RAMP REPORT REGION 2 ADA 2026

Route 7 – Vine Street
Belfast

CR16701

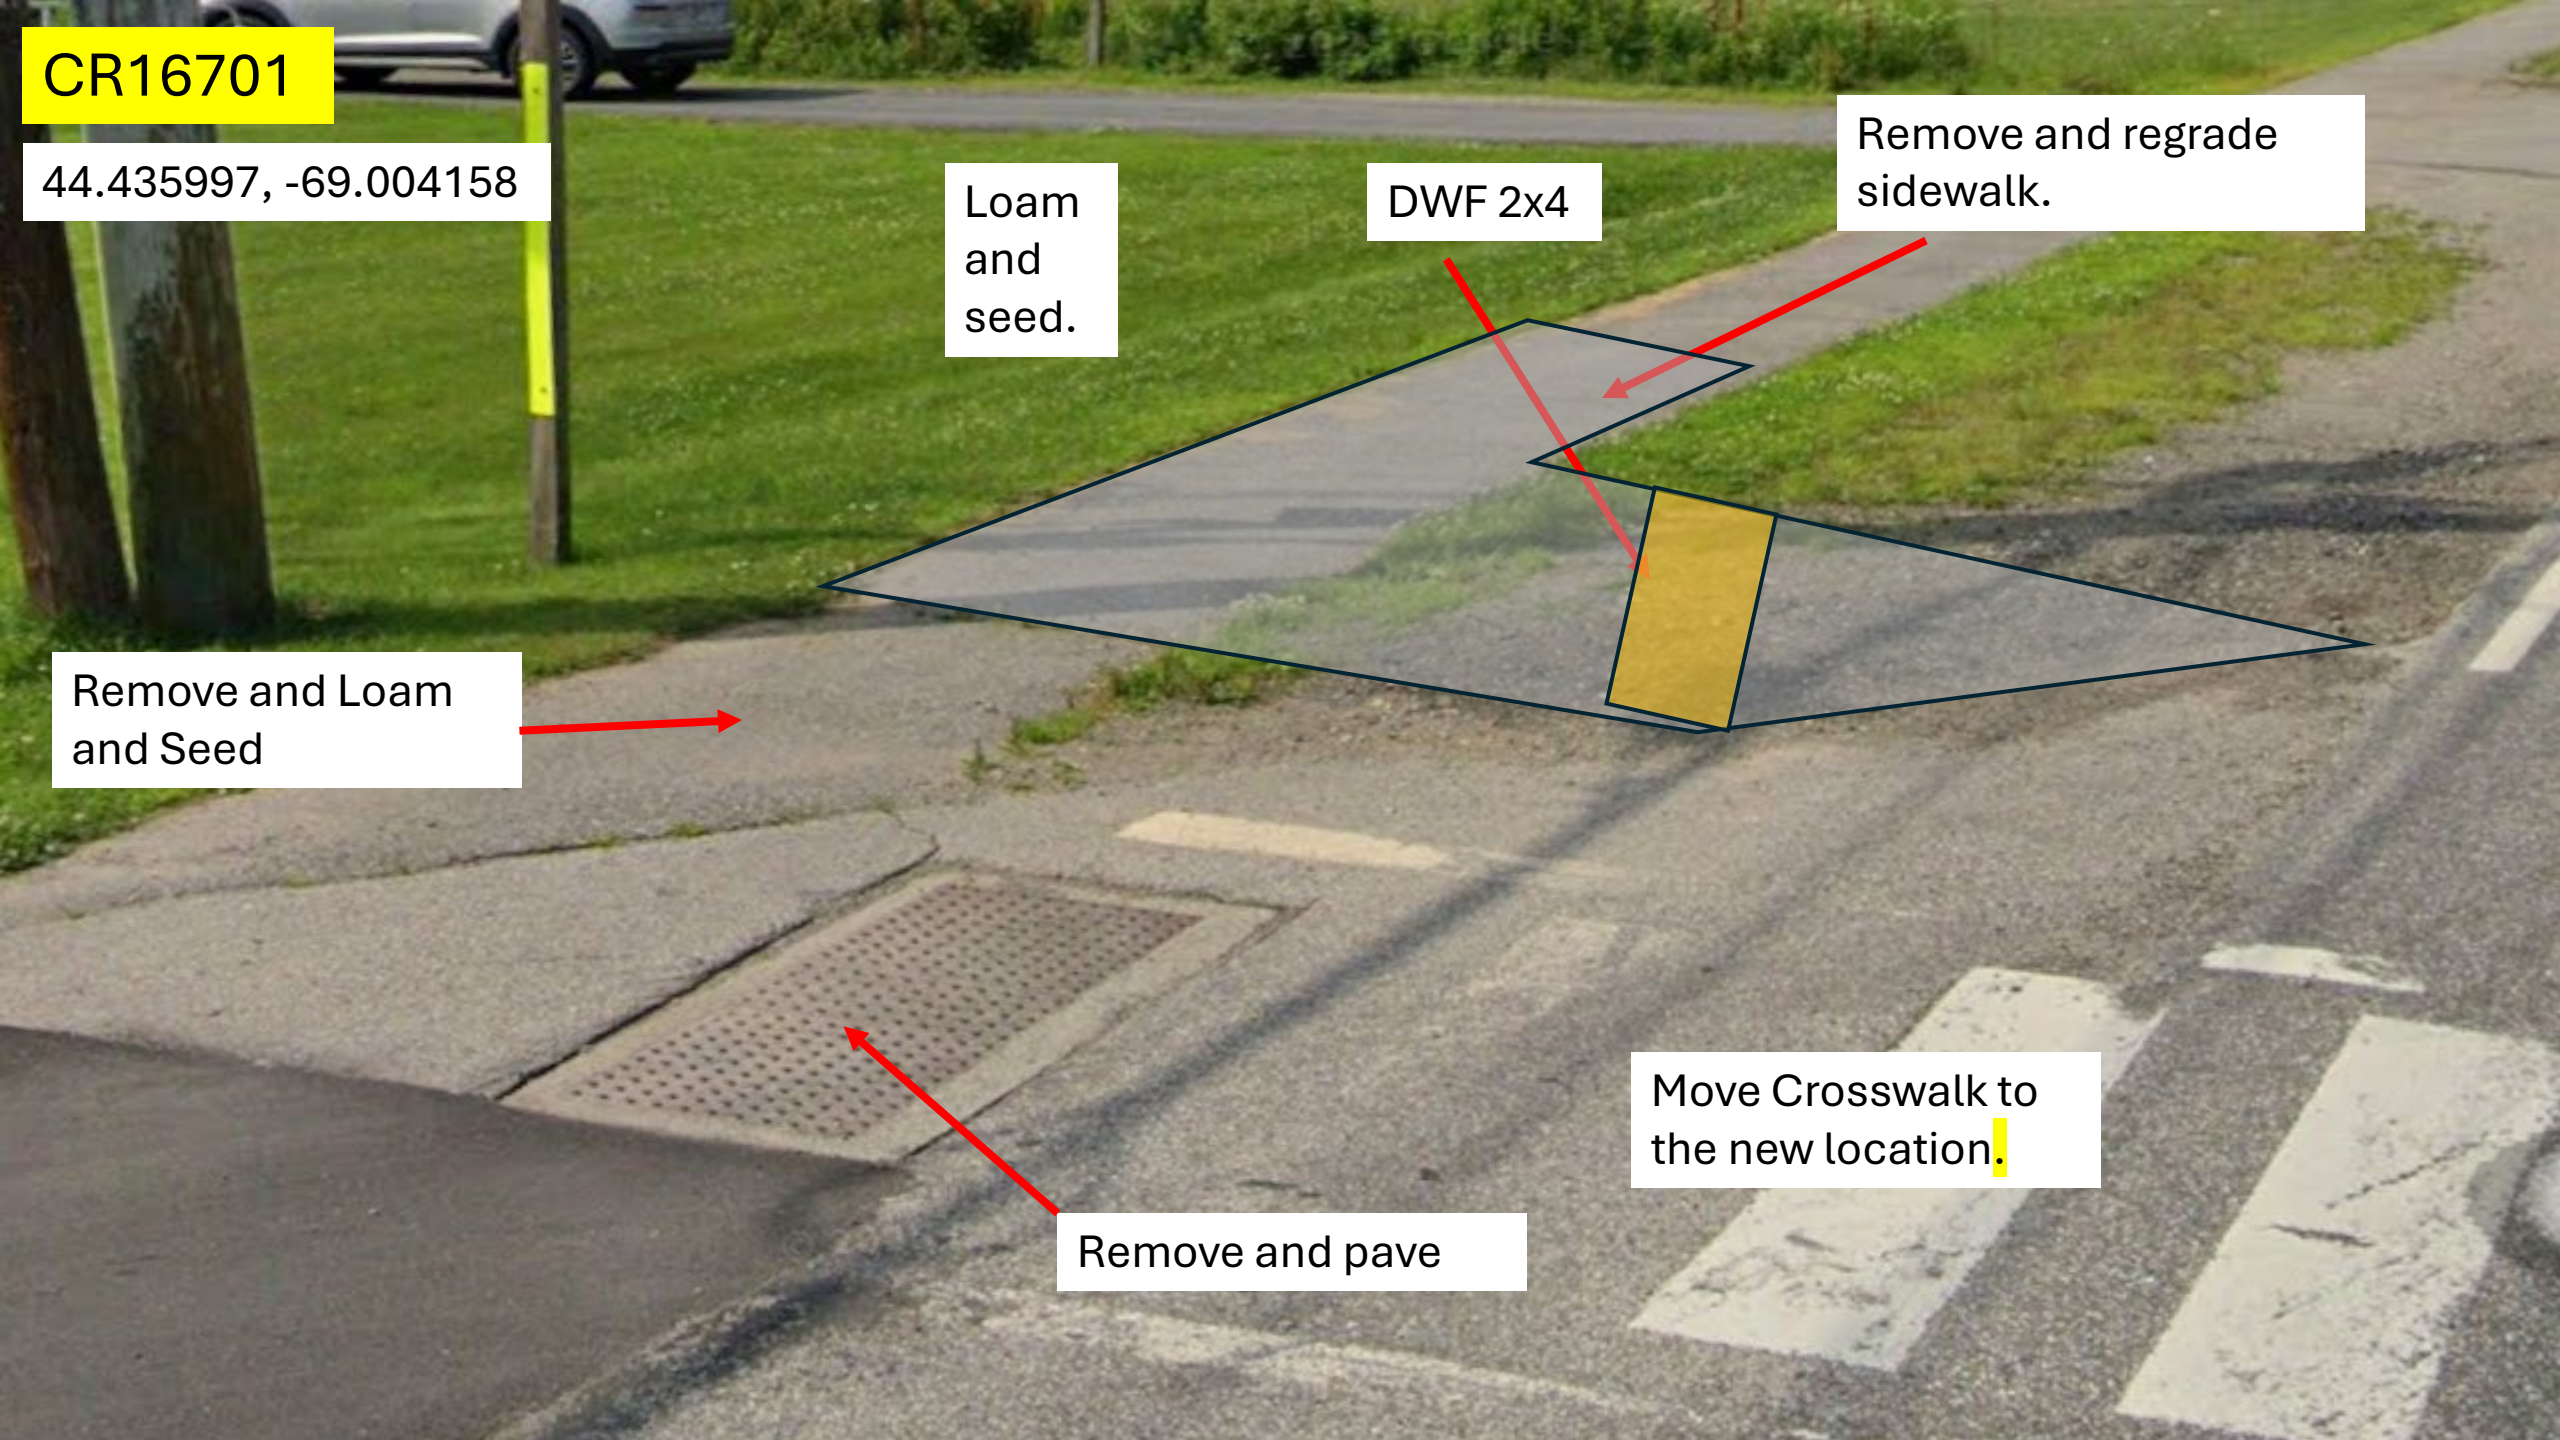
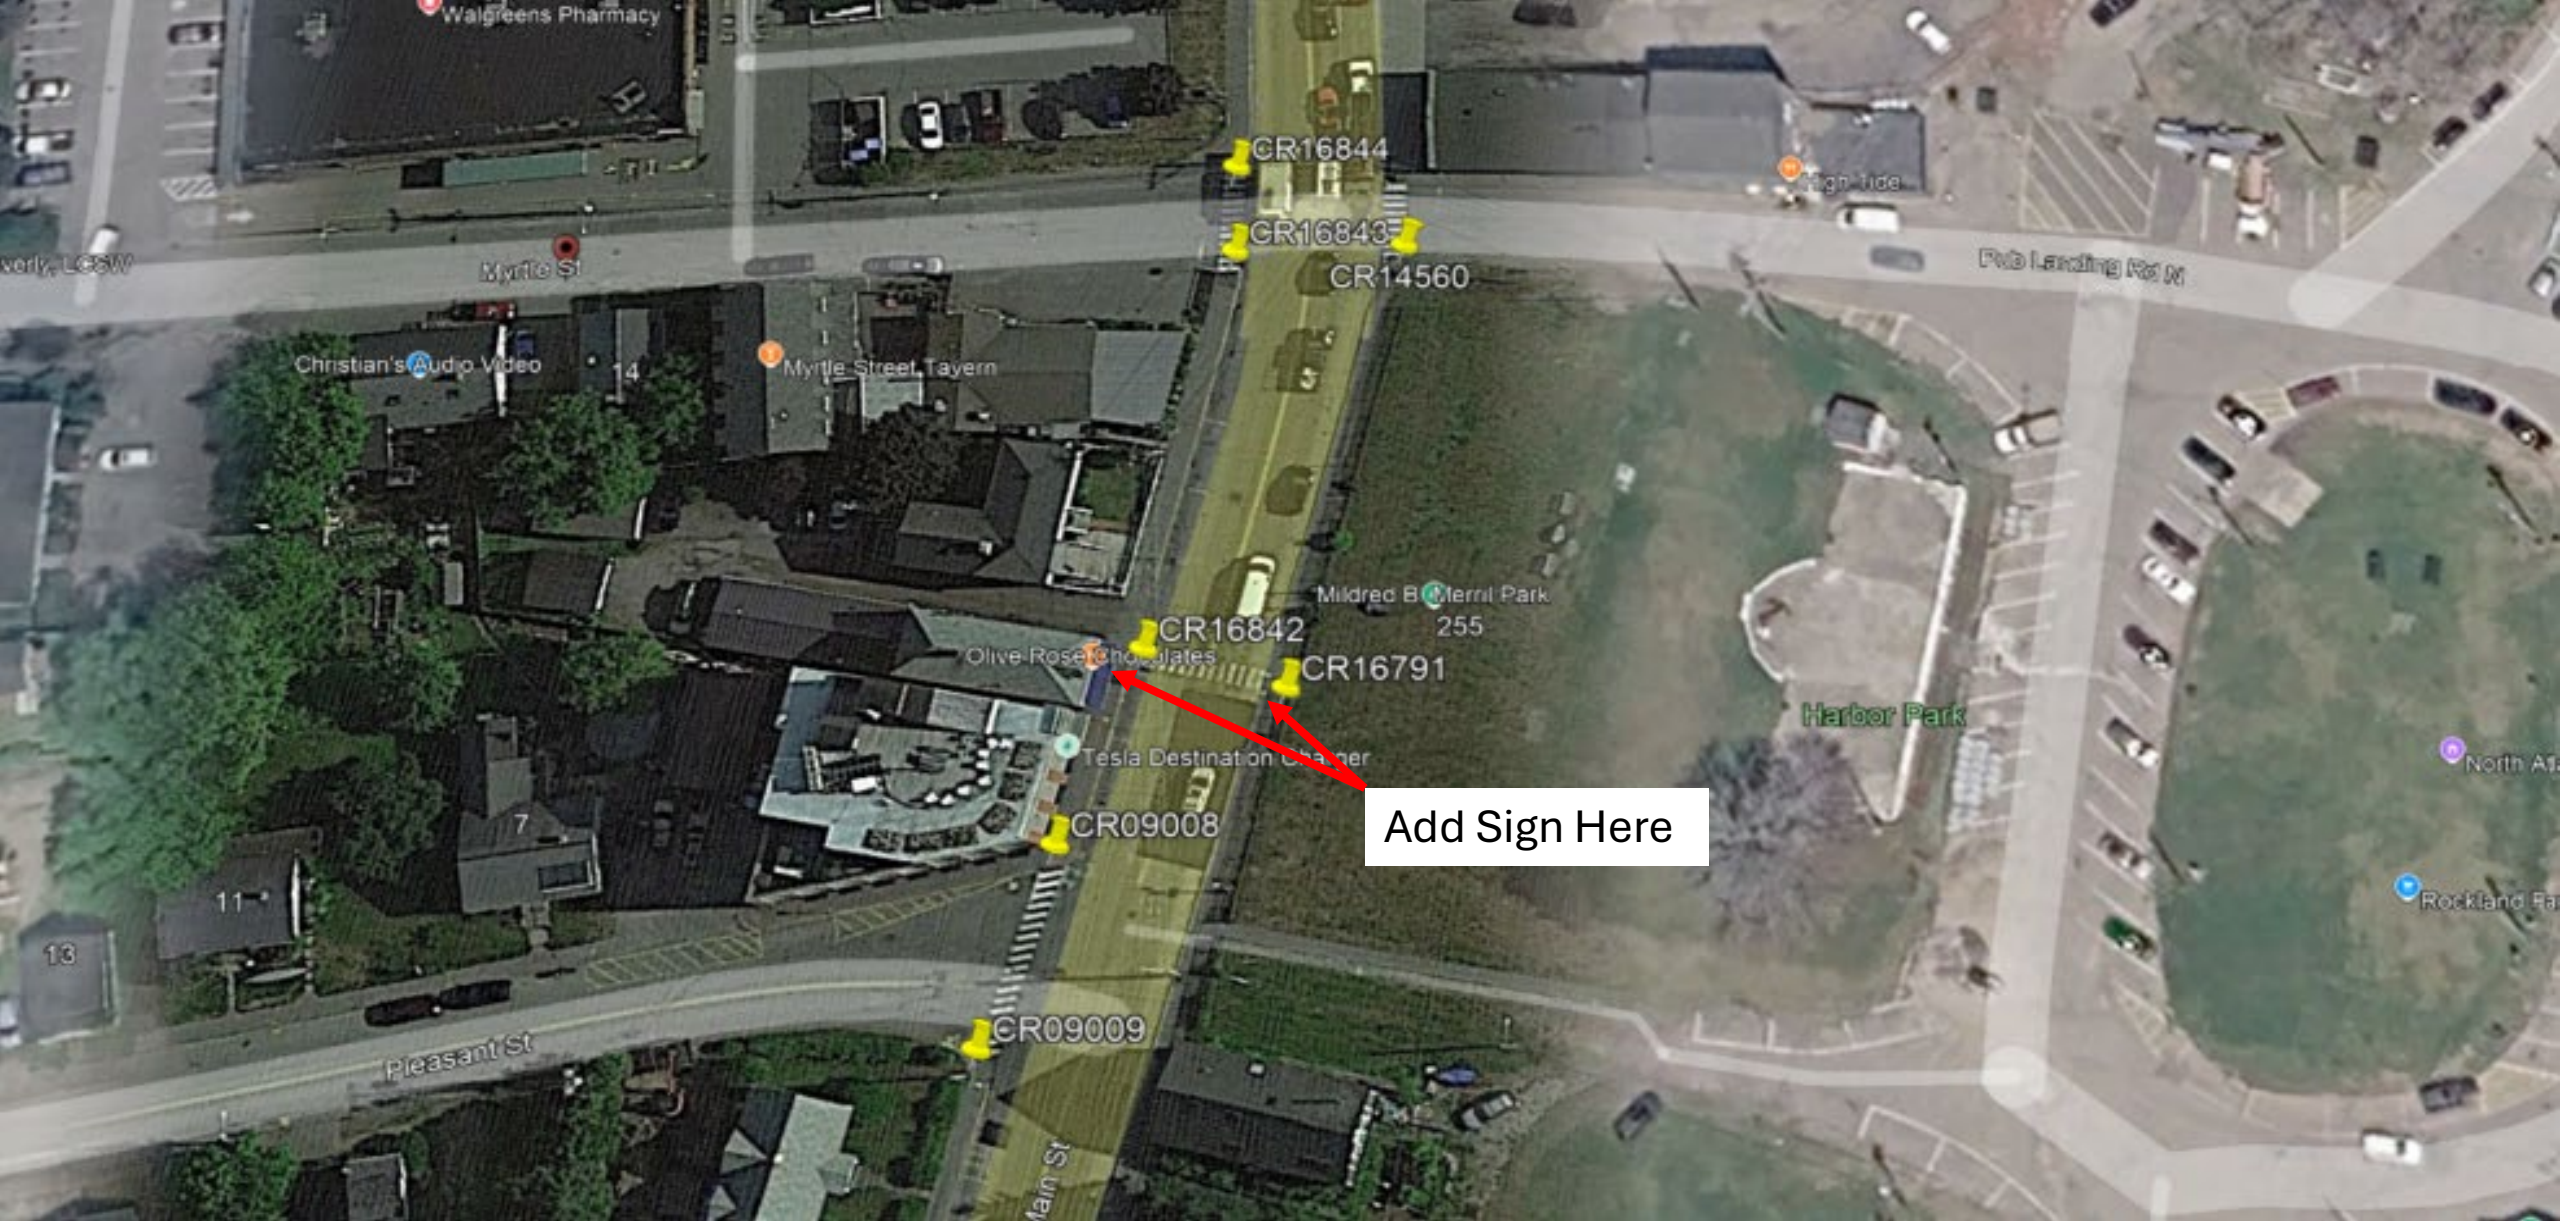
Loam
and
seed.

DWF 2x4

Remove and regrade
sidewalk.

Remove and Loam
and Seed

Move Crosswalk to
the new location.

Remove and pave

CR16844

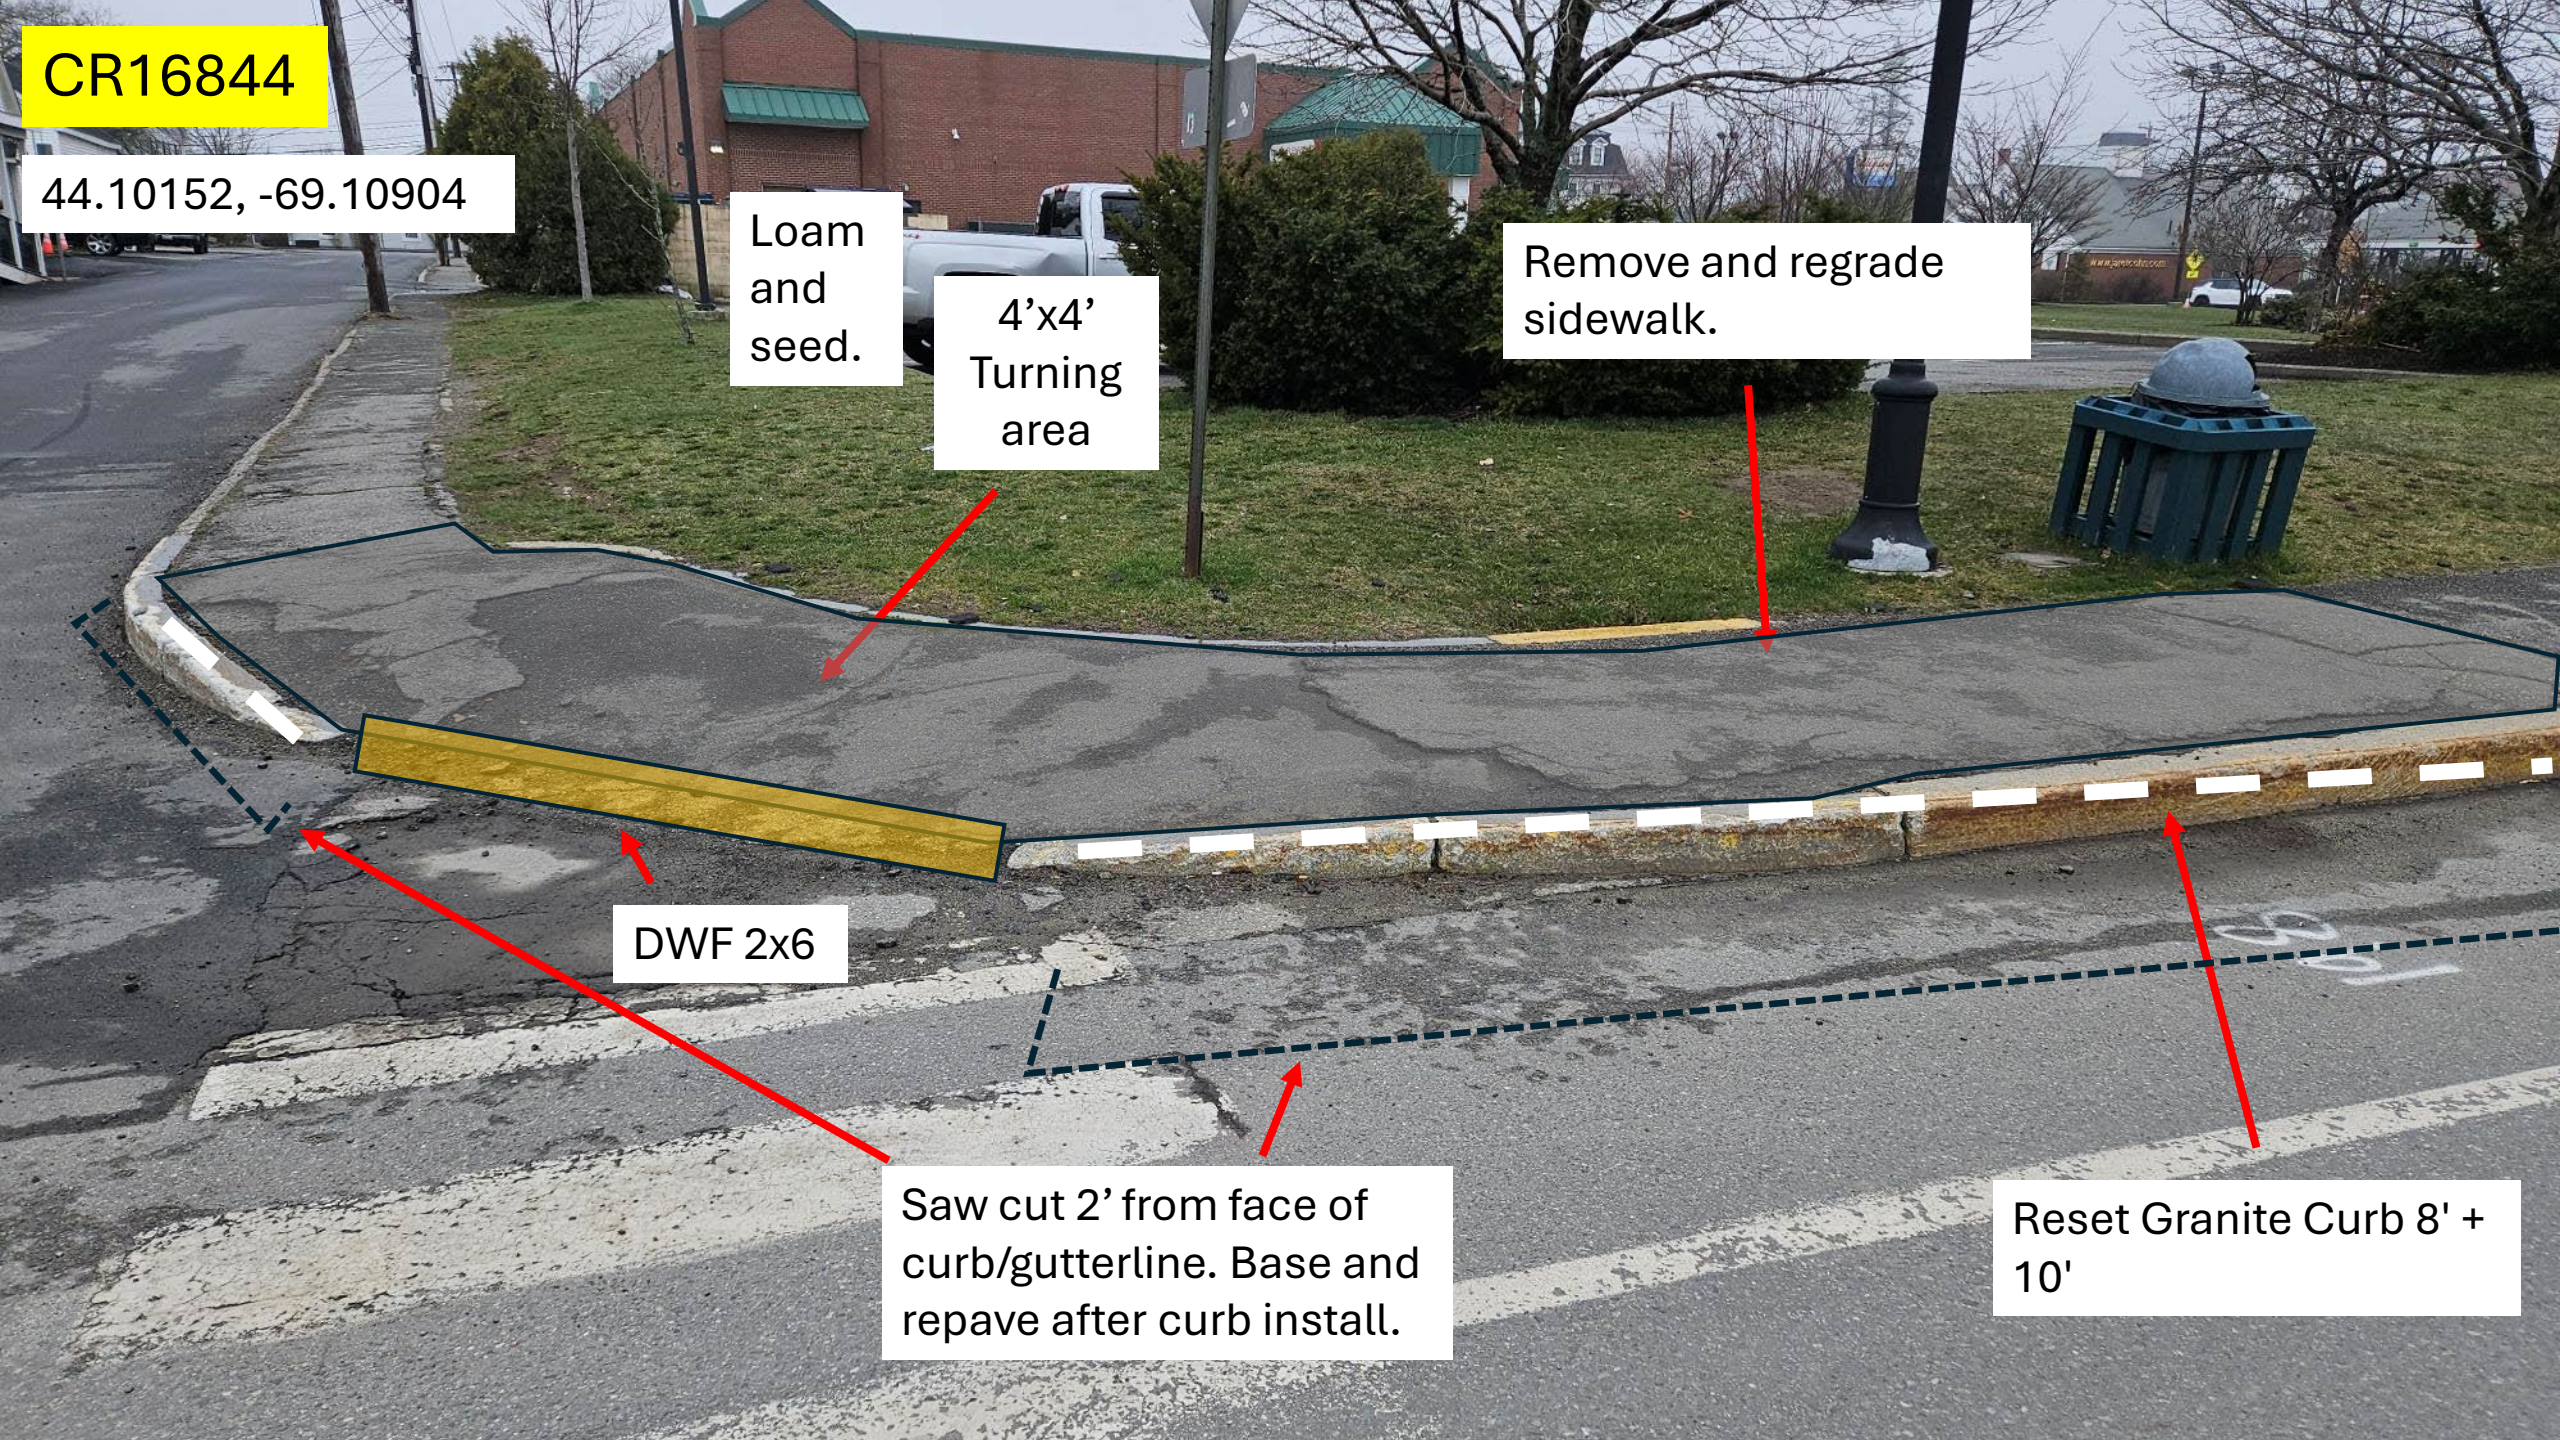
Loam
and
seed.

4'x4'
Turning
area

Remove and regrade
sidewalk.

DWF 2x6

Saw cut 2' from face of
curb/gutterline. Base and
repave after curb install.

Reset Granite Curb 8' +
10'
